**CITY OF MILWAUKIE
PLANNING COMMISSION
MINUTES
Milwaukie City Hall
10722 SE Main Street
TUESDAY, May 11, 2010
6:30 PM**

5.1 Summary: Riverfront Park
Applicant/Owner: City of Milwaukie
File: DR-09-01, TPR-09-03, WG-09-01, WQR-09-01, and VR-09-03
Staff Person: Ryan Marquardt

Milwaukie Riverfront Park

MATCHLINE -- SEE FIG 4B

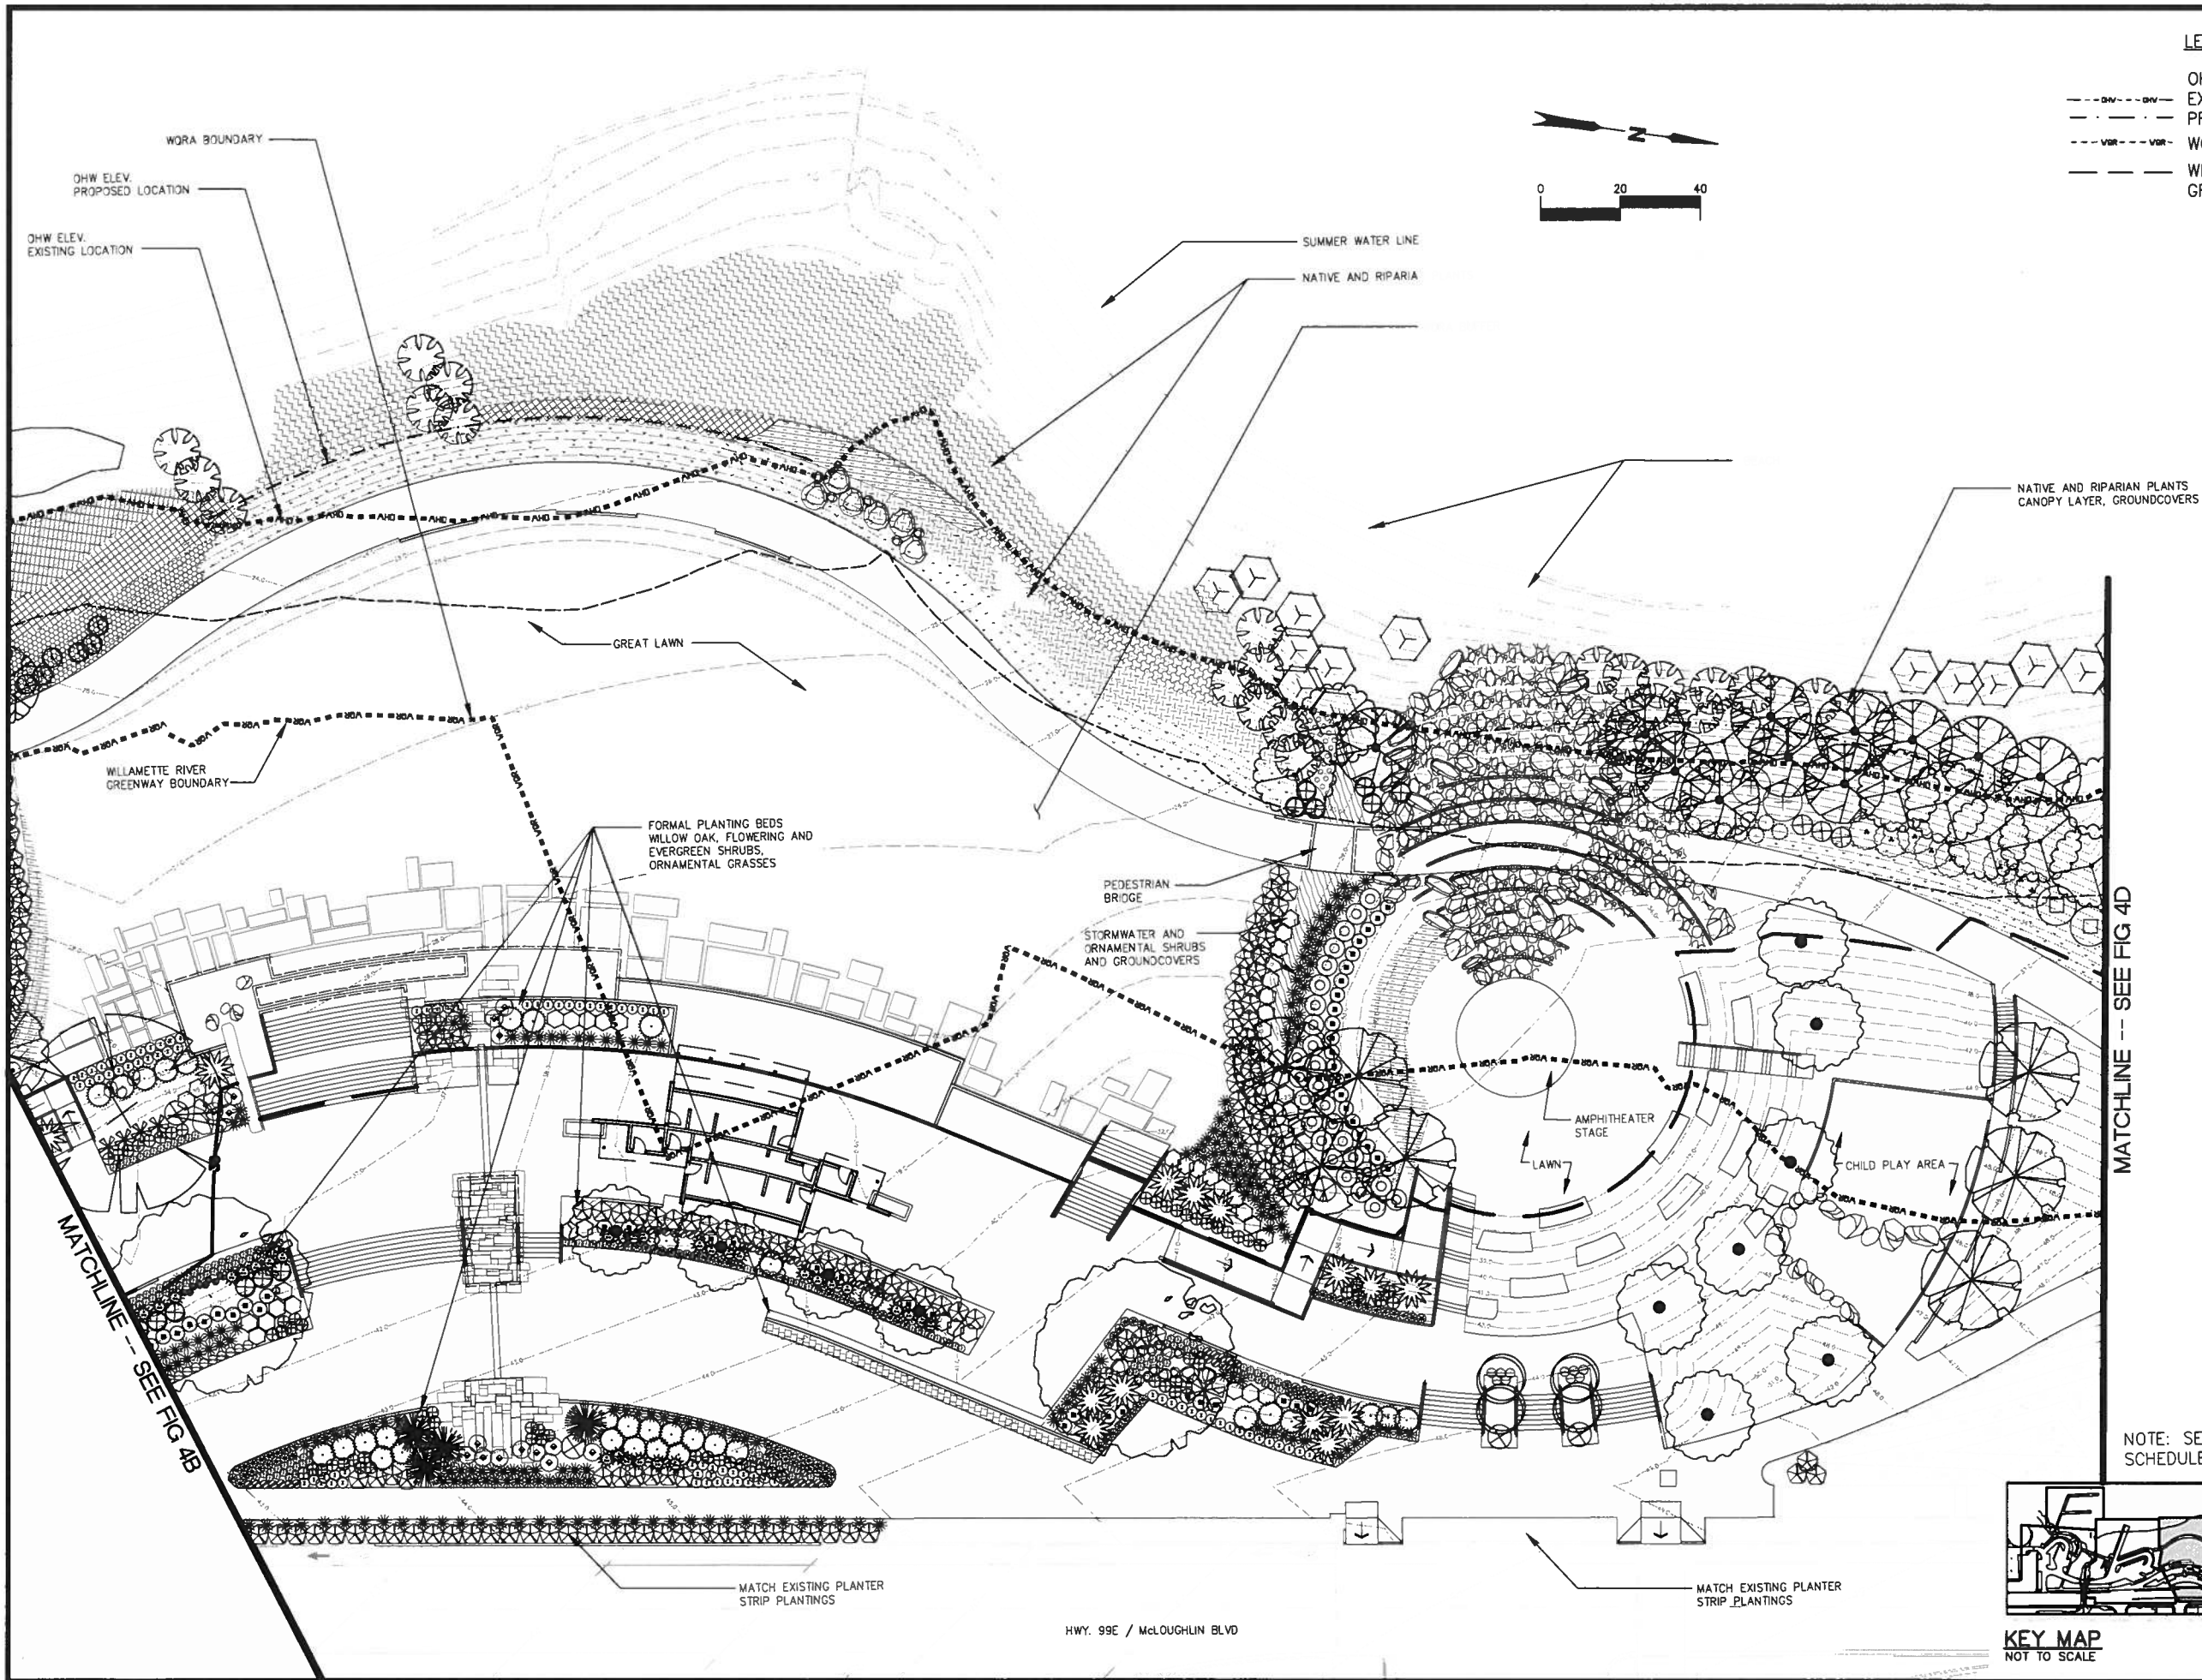
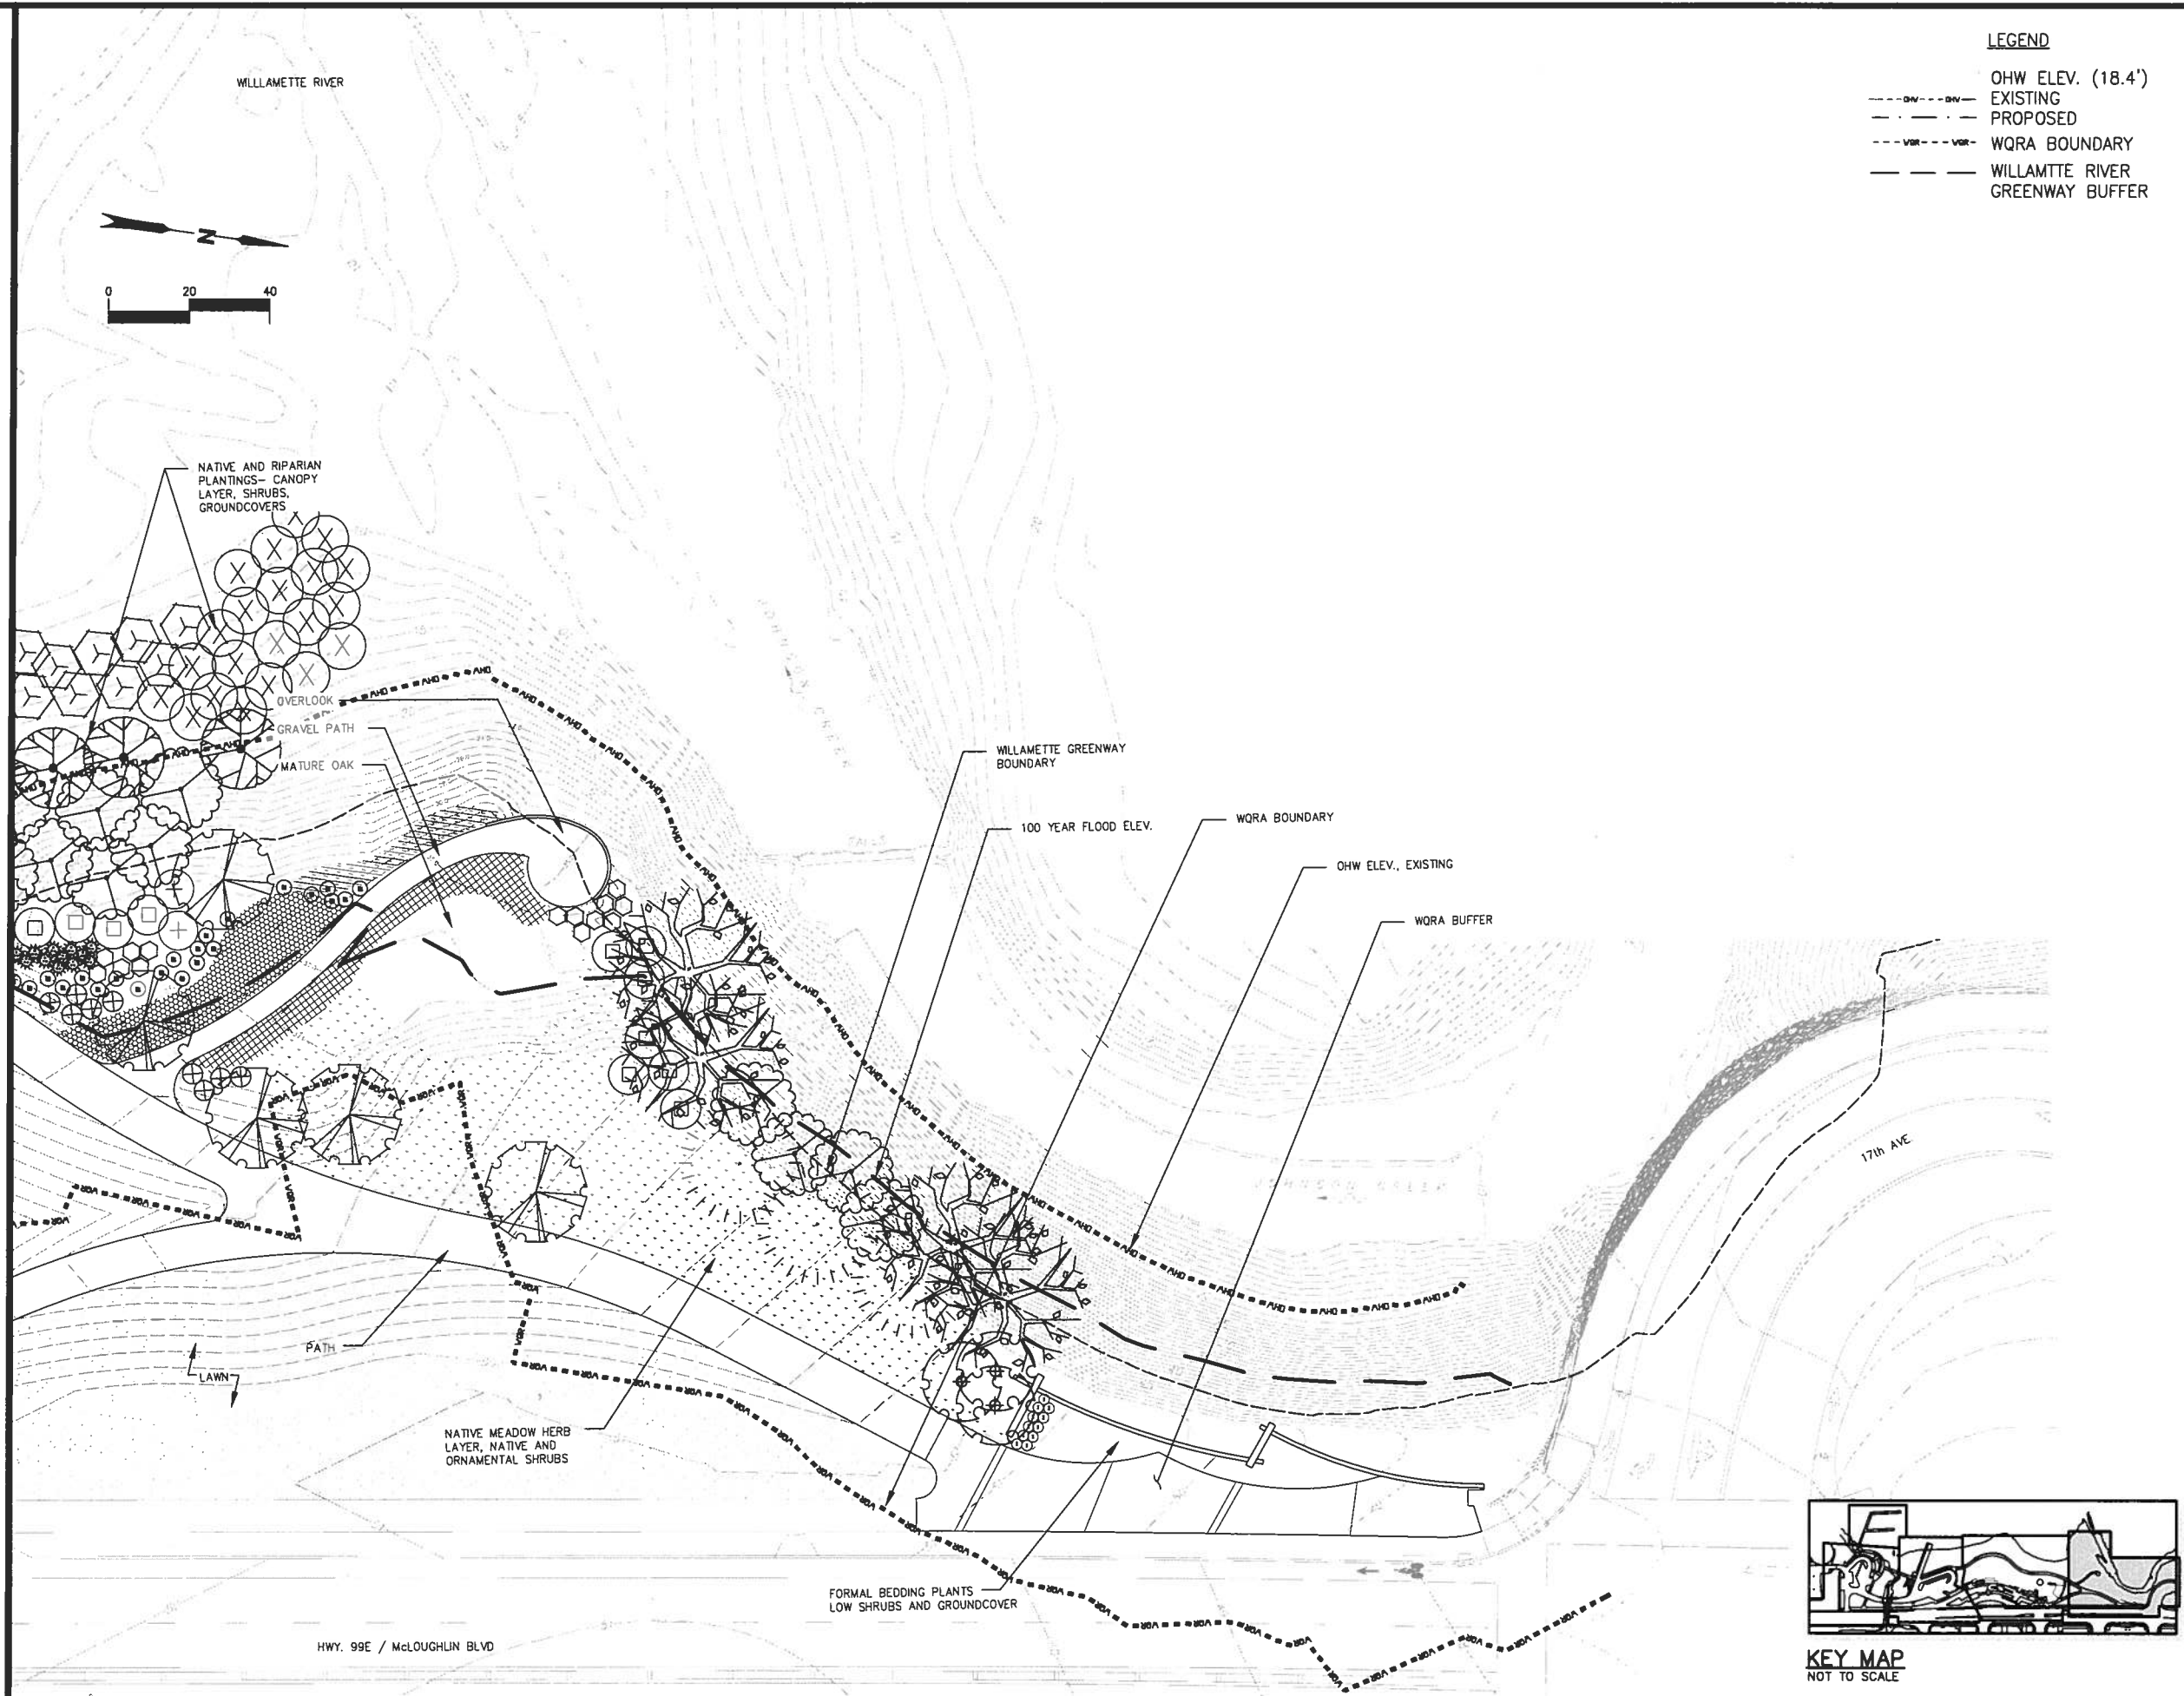
Non-native trees and shrubs are apparently listed for installation within the WQRA on Figure 4 of Appendix B (“Tab” B). We recommend using only native species identified on the Metro native plant list in the WQRA. Metro is currently referencing the City of Portland native plant list while its list is updated: <http://www.oregonmetro.gov/index.cfm/go/by.web/id=27023>. Table 1 lists non-native species apparently designated for installation in the WQRA; and native analogs that could be substituted. Additionally, Figure 4 should list the complete scientific name of all proposed plants, not just the genus in some cases.
- L. Sufficiently addressed.

- H3. The General Site Mitigation Plan and Figures 4, 4A – 4D provided in the supplemental information document (item 1 in the bulleted list above) provide information about mitigation that sufficiently responds to comments provided regarding this requirement.

- I1. Adverse impacts are described in the alternatives analysis documents.
- I2. The General Site Mitigation Plan and Figures 4, 4A – 4D and the alternatives analysis provided in the supplemental information document (item 1 in the bulleted list above) provide information about mitigation that sufficiently responds to comments provided regarding this requirement.
- I3. Sufficiently addressed in the initial application.
- I4. The project is described as “self-mitigating” and a specific mitigation site is not identified.
- I5. The General Site Mitigation Plan and the alternatives analysis provided in the supplemental information document (item 1 in the bulleted list above) provide the requested information.
- J. A stand-alone mitigation plan document is not present. The information that would be included in the mitigation plan is present elsewhere in the application materials.
- K. NA

- K. The General Site Mitigation Plan and Figures 4, 4A – 4D and the alternatives analysis provided in the supplemental information document (item 1 in the bulleted list above) provide information about mitigation that sufficiently responds to comments provided regarding this requirement.
